Redevelopment Proposal of 2 - 16 Clifton Down Road by THAT Group

Technical Review of Eb7 Daylighting and Sunlighting Statement  
for  
Clifton & Hotwells Improvement Society  
and  
Mall Garden's Residents Association

15 March 2019

### Daylighting Diagram for Kings Road as Existing

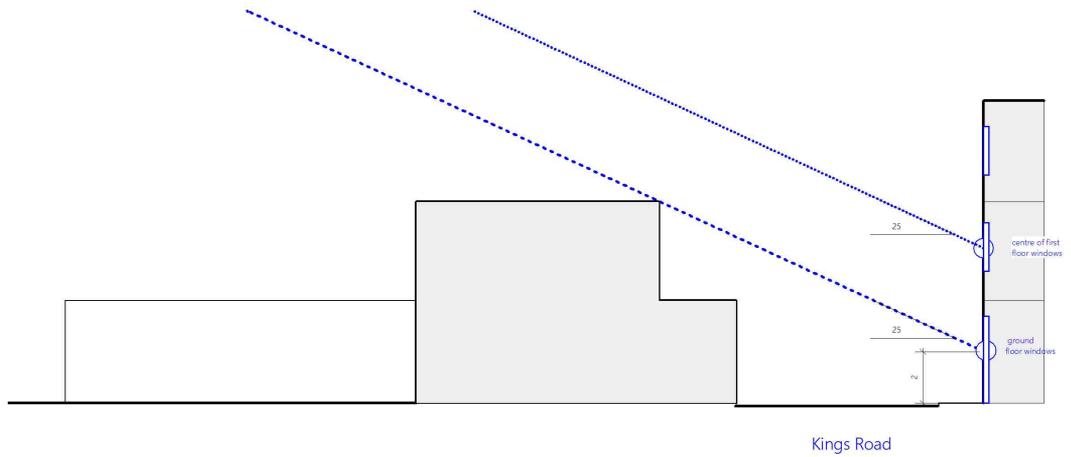
The diagram makes it clear that the setback of the existing building preserves good daylighting to both the shop windows on Kings Road as well as the assumed residential accommodation above. Had the two storey building been built right up to the back of pavement the achievement of 27% VSC daylighting could not have been assured.

### Daylighting Diagram for Kings Road as Proposed

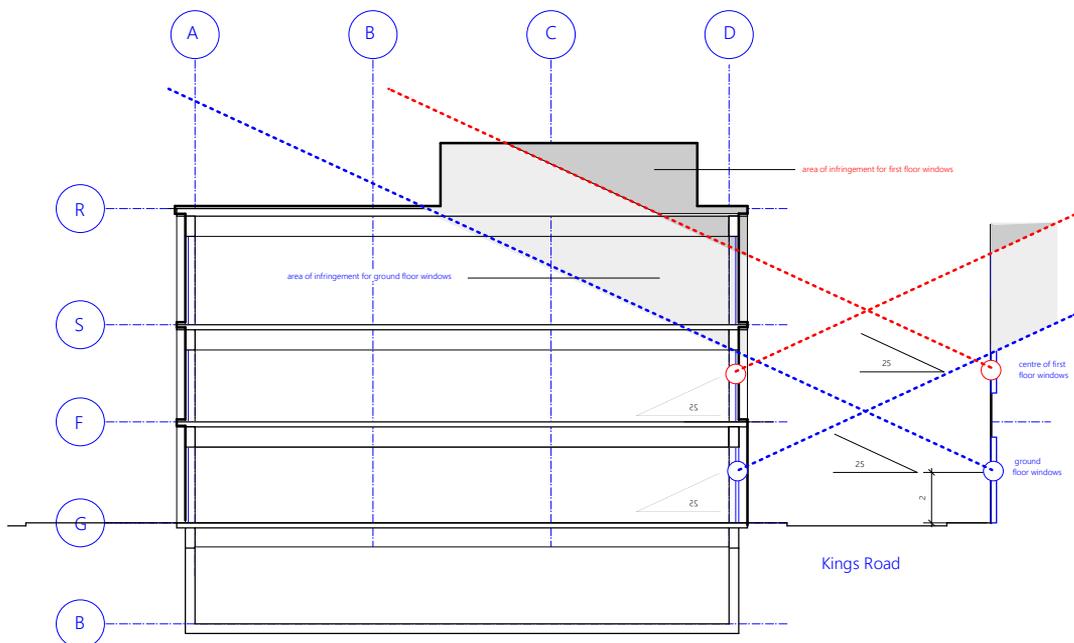
The diagram makes it clear that the proposed building fails to comply with the 25 degree test and that full VSC calculations are required. The evidence would suggest, as the proposed building presents a continuous skyline, is that good daylighting would **not** be preserved neither to the shop windows on Kings Road nor to the assumed residential accommodation above.

Daylighting Diagram for Kings Road Existing and Proposed

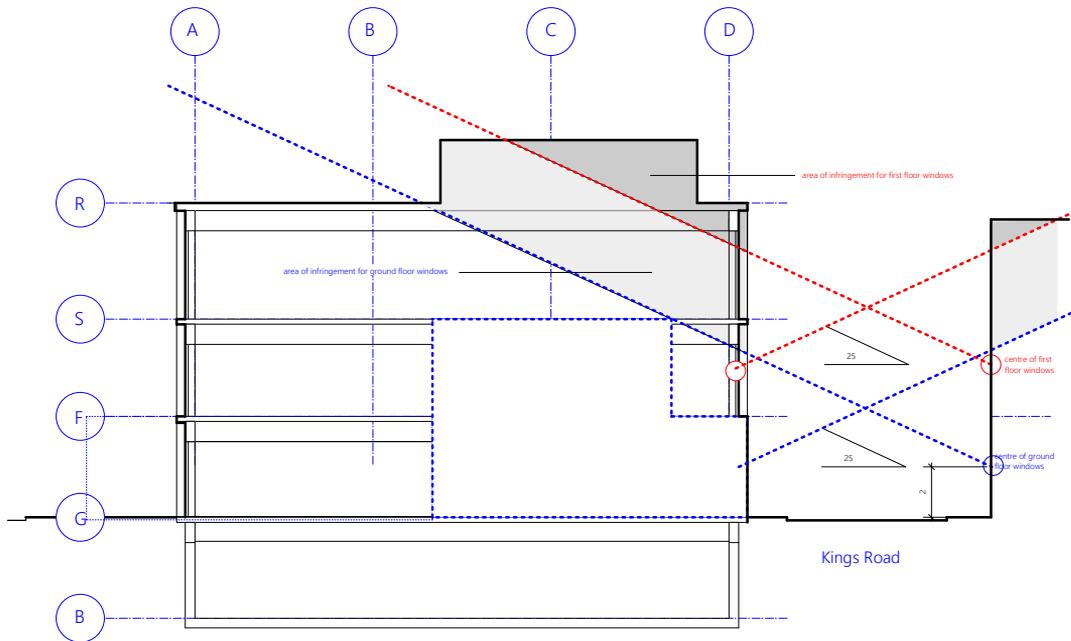
In addition, the tall narrow street thus formed would be devoid of sunlight except for just a few hours in the morning. The street would be without sun from midday onwards.
